APPLICATION NO.	FILING DATE	FIRST NAMED INVENTOR	ATTORNEY DOCKET NO.	CONFIRMATION NO.
10/090,287	03/01/2002	Peter G. Borden	BOX014 US	6609

Office Action Summary

DETAILED ACTION

Attachment

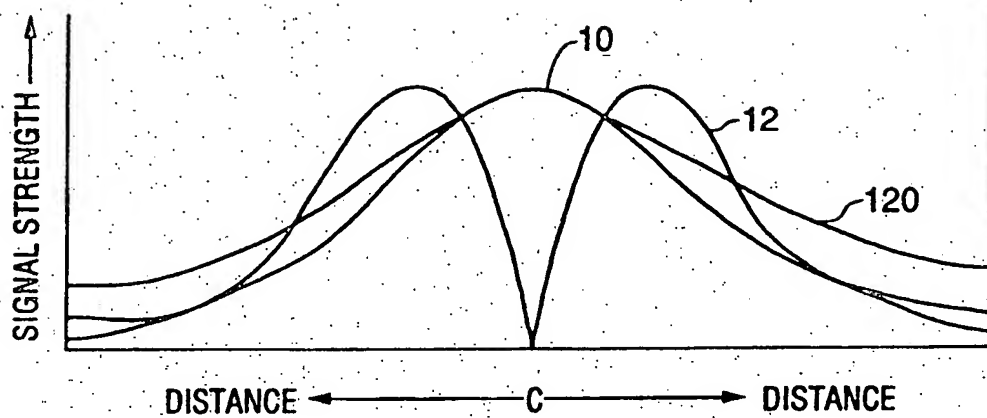
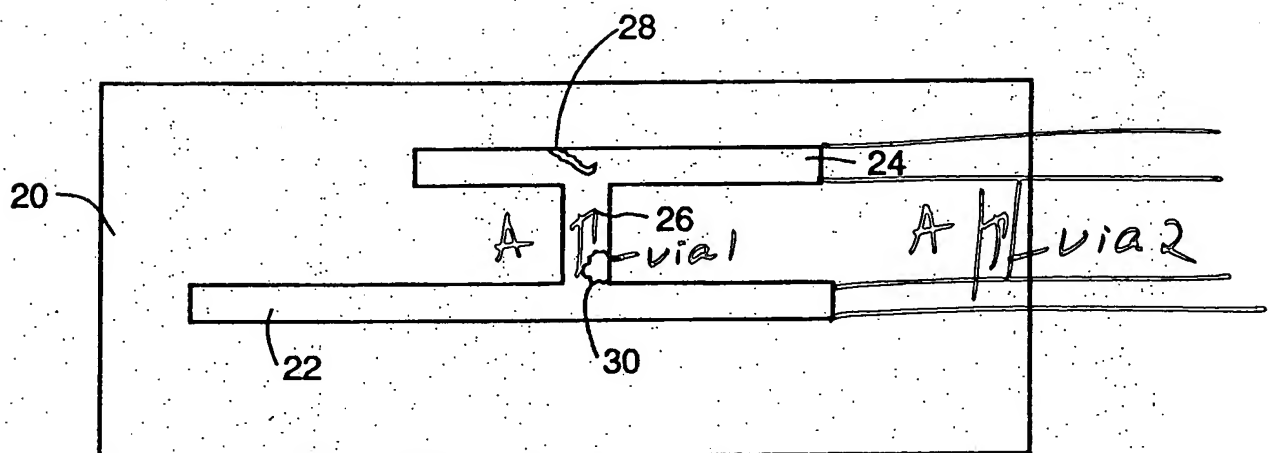
Smith discloses in Figs. 1-4 a device and the method in the field of applicant's endeavor for testing an integrity (defect, flaw, quality, irregular features) of a semiconductor wafer with a first conductive structure/ layer/ portion (metal lines and plurality of vias, thus, inherently periodic in space along a direction A). The device comprises a modulated laser pump (pump beam, electron beam) 44 incident to a surface of the metal lines to evaluate vias. Smith also discloses another laser beam (probe beam) 60, a reflected probe beam is received by a thermal detector 74. The reflection of the probe beam is used to obtain measured results and to compare them to a known wafer pattern (reference wafer/ second conductive structure) results stored in memory. (the numeral A has been added by the Examiner, see attachment to the Office action).
